RE: Former Alcoa Building 12, Edgewater, NJ - Soil Stockpile

Former Alcoa Building 12

Former ALCOA Facility – Building 12 (NJDEP #97-6-10-0037-28) 700 River Road Edgewater, New Jersey 07020

Figure 16 Remaining Soils.pdf; 20160114 Alcoa Building 12 Response to USEPA.pdf

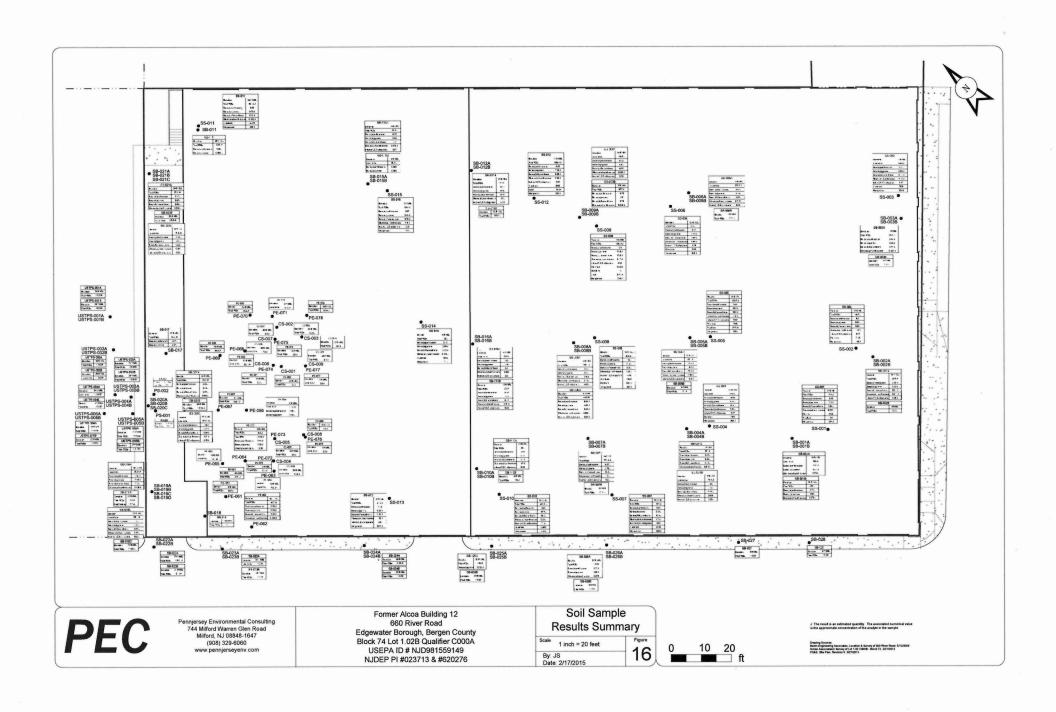
At the Agency's request, PEC included a figure in our March 18, 2015 Remedial Investigation / Remedial Action Report / Remedial Action Workplan (RI/RAR/RAWP) that showed the data for the soil sample locations remaining on the site following the completion of the remediation and the installation of the Interim Remedial Measure (IRM). This figure, designated in the RI/RAR/RAWP as Figure 16 and attached hereto, indicated four soil sample locations where the remaining soils exceeded 500 milligrams per kilogram (mg/kg) total PCBs. These data have been summarized below.

In the above table, we have indicated both the sample elevation in feet mean sea level (ft MSL) and the contemporaneous observed depth in feet below ground surface (ft bgs). Figure 16 showed the sample elevations in ft MSL, while the observed depths in ft bgs were referenced elsewhere in the text as well as Figures 5 and 6 of the RI/RAR/RAWP.

Soil samples PS-001 and PS-002 were collected on February 26, 2014 from locations on the excavation sidewall immediately below the protruding ends of the product piping. The result of the duplicate sample DUP-004, collected from location PS-001, was significantly less than the compliance sample, indicating the heterogeneity of the soil matrix. These locations were shown on Figures 6 and 16. These soils were subsequently excavated on March 18, 2018; however, a new sample could not be collected immediately thereafter as PEC judged that it was not safe to enter the area, i.e., it would have violated the Occupational Safety and Health Administration excavation safety standard (29 CFR 1926 Subpart P) and it was not feasible to collect a sample from the side wall using a backhoe bucket because of the elevation. Shortly thereafter, the construction contractor, Schulman Industries, stabilized the excavation sidewall by constructing a concrete block retaining wall along the face of it, separating the area of the former basement floor and UST vault from the excavation wall and the adjoining property and thus preventing access for the collection of soil samples. See section 3.2.4.2 of the RI/RAR/RAWP for a discussion of this sampling event; the concrete block wall is shown on both Figures 6 and 16.

Soil samples PE-061 and PE-063 were post excavation soil samples related to the former USTs that were collected on March 21, 2014 from the surface of the competent fractured bedrock at depth of approximately 20 ft bgs. Further vertical excavation was not feasible, but there was no visual indication oil staining. These sample locations were shown on Figure 8 and Figure 16. Subsequent to PEC's collection of these samples, PEC observed that the UST excavation had been backfilled with clean fill material up to the existing grade. The IRM was later constructed on top of this backfill using the geotextile fabric and six inches of crushed stone. Both of these efforts were reported in Section 3.5.1 of the RI/RAR/RAWP. The IRM was completed on September 12, 2014 and the site released to general construction on September 17, 2014. PEC did not at any time subsequent to the collection of post excavation soil samples PE-061 and PE-063 observe evidence that additional soil had been excavated from that area of the site. To our knowledge, these soils were not re-excavated after collection of the post excavation soil samples PE-061 and PE-063 in March 2014.
